January 7, 2016

Master Sign Plan

15-099MSP – BSD Scioto River Neighborhood District

Bridge Park B & C Blocks – Riverside Drive

Window Signs/Window Graphics

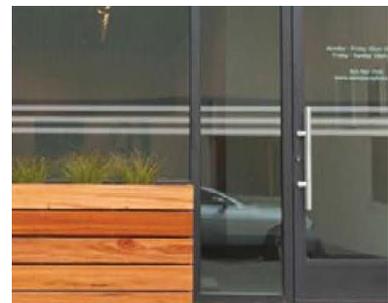
At ART's recommendation, the applicant has included definition for Window Sign and Window Graphic where a Window Sign would count as one of a tenant's permitted signs, and a window graphic would not count. It should be clarified that window graphics require landlord approval; and, if the intent is that window graphics and window signs shall *each* not be more than 30% of the window area or if summed they shall not be more than 30% of the window area.
